600 BLOCK MAIN STREET

Buffalo, New York

March 16, 2011

90% Layout Plan

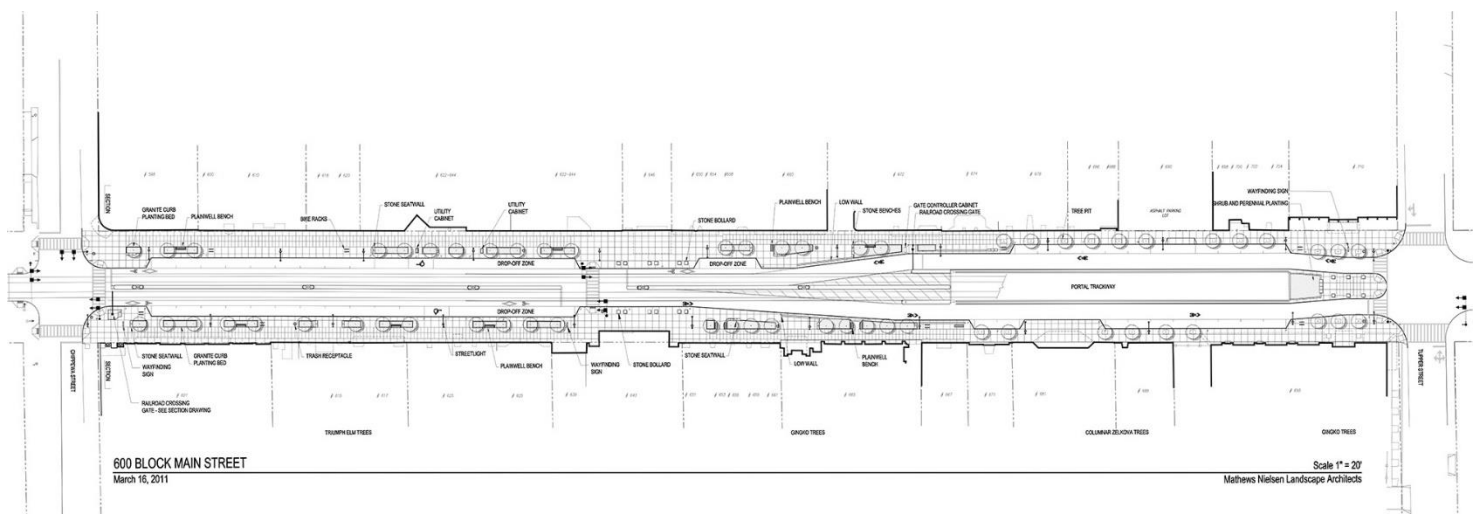
The 70% Concept A Layout with trees in formal rows was selected during the January review period. At the request of several theater operators, five trees will be relocated to a nearby site, so that views of the Alleyway Theatre sign and the 710 Playhouse Marquee (former Studio Arena Theater) will not be blocked, as is appropriate in a theatre district. An additional rail road crossing arm will be placed at the north-east corner of Chippewa and Main Street, so that northbound automobile traffic can be automatically stopped in case NFTA has to run Metro Rail on a single track during a repair or construction.

Portal Fence

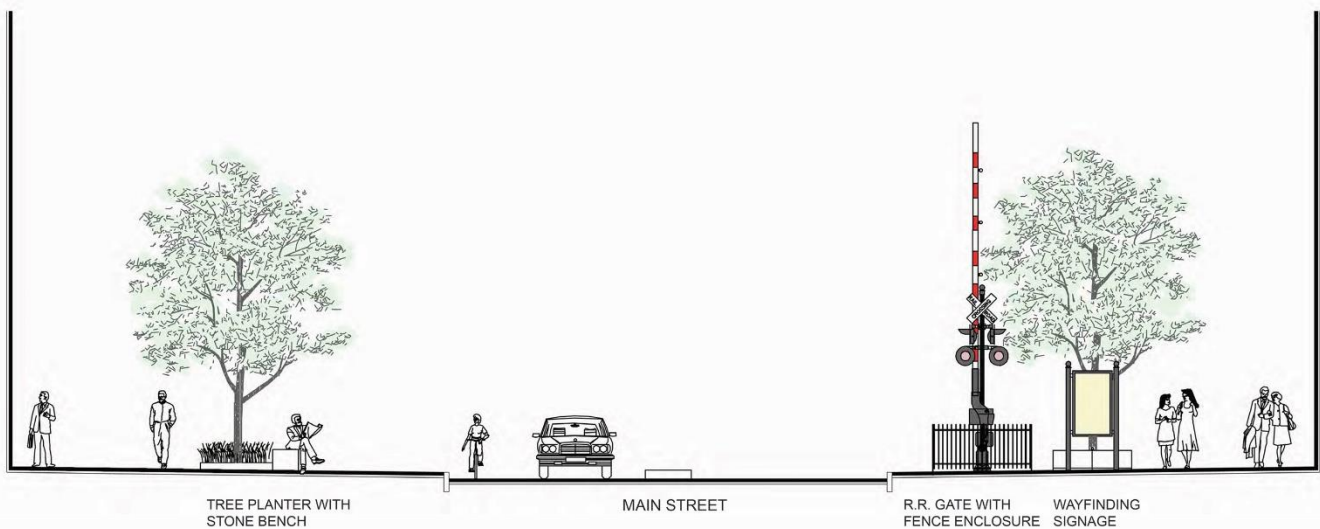
Two alternative fence materials were discussed to enclose the portal where the train emerges from underground. The goal was to select the most transparent fence style to ensure visibility of storefronts across the street. DOT construction projects must use steel manufactured in the USA, so different materials were considered than at the 70% level. Theatre District representatives selected the vertical, stainless steel, ½ inch diameter round pickets, rather than the grid design similar to fencing used in the Erie Canal Harbor area.

Decorative panels had been discussed at the 70% design stage, but were dropped from the design during the meeting because they didn't seem to provide sufficient benefit. They were thought to block the cross street view and are too narrow to provide a useful message.
